Access Compliance Report

Public Rights-of-Way

(Curb Ramps)

Intersection ID: 28622	Main Street: PEDLAR_MILLS_RD	Cross Street: STRINGFELLOW_LN	Location: NW
ADA ID: 6F2301FC129D	Ramp Type: PerpDiag	Initial Pass/Fail: Fail	Overall Compliance: No
Severity Score: 10			
Codes/Mitigation Info/Possible Solution		Field Measurements/Component Compliance

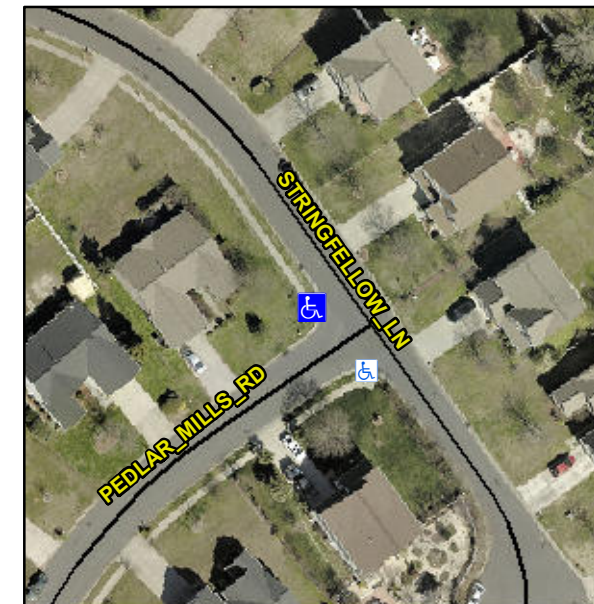
R304.5.1, R304.5.3

Compliance	Description	Data	Compliance	Description	Data
N/A	Ramp Length (in)	51.0	Yes	Ramp Slope (%)	7.7
No	Ramp Width (in)	42.3	No	Ramp XSlope (%)	3.5
N/A	Flare Type LT	N/A	N/A	Flare Type RT	N/A
N/A	Flare Slope LT (%)	N/A	N/A	Flare Slope RT (%)	N/A
N/A	Flare Traversable LT?	N/A	N/A	Flare Traversable RT?	N/A
N/A	Landing Length (in)	N/A	N/A	DWS Provided?	N/A
N/A	Landing Width (in)	N/A	N/A	DWS Contrast?	N/A
N/A	Landing Slope (%)	N/A	N/A	DWS Length (in)	N/A
N/A	Landing X Slope (%)	N/A	N/A	DWS Full Width?	N/A
N/A	Landing Curb? (Y/N)	N/A	N/A	DWS Offset (in)	N/A
N/A	Shared Landing?	N/A			
N/A	Gutter Ponding?	N/A	N/A	Gutter Slope (%)	N/A
N/A	Gutter Lip Ht (in)	N/A	N/A	Gutter X Slope (%)	N/A
N/A	Painted X Walk1?	No	N/A	Painted X Walk2?	No
	X Walk 1 Direction	To SE		X Walk 2 Direction	To NE
N/A	X Walk 1 Width (in)	N/A	N/A	X Walk 2 Width (in)	N/A
	X Walk 1 Slope (%)	1.1		X Walk 2 Slope (%)	6.1
	X Walk 1 X Slope (%)	0.5		X Walk 2 X Slope (%)	1.1

Remove & Replace Curb Ramp With Two New Directional Ramps or Equivalent.
